From: Richard Simpson [REDACTED]
Sent: 13 August 2017 06:58
To: Planning
Subject: Morrisons application Camden Goods Yard 2017/3847/P Advice from Primrose Hill CAAC and from Regent's Park CAAC
Attachments: Advice from RPCAAC Morrisons 2017.pdf; PHCAAC Advice Morrisons August 12 2017.pdf; Barratts Morrisons PHCAAC letter March 2017.pdf; Barratt letter December 21 2016 rv2.pdf

ADVICE from Primrose Hill Conservation Area Advisory Committee
12A Manley Street, London NW1 8LT

Morrisons Store and Petrol Station, Chalk Farm Road, NW1 8EH 2017/3847/P

Advice from The Regent's Park Conservation Area Advisory Committee

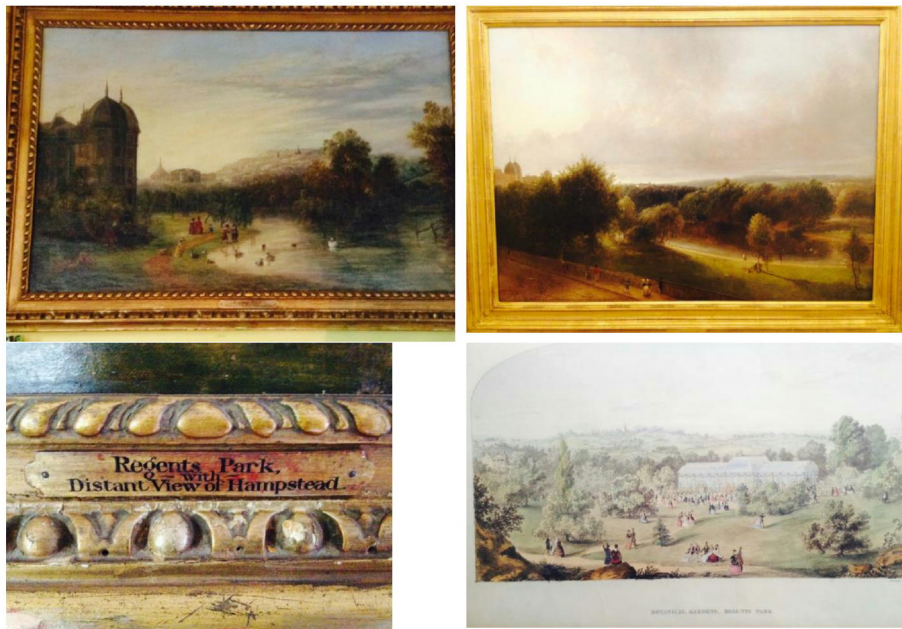
10. Recognition of these views is also witnessed by contemporary artists who celebrated it in paintings and engravings. We illustrate two of these. We are grateful to the private owners for allowing us to use these images.
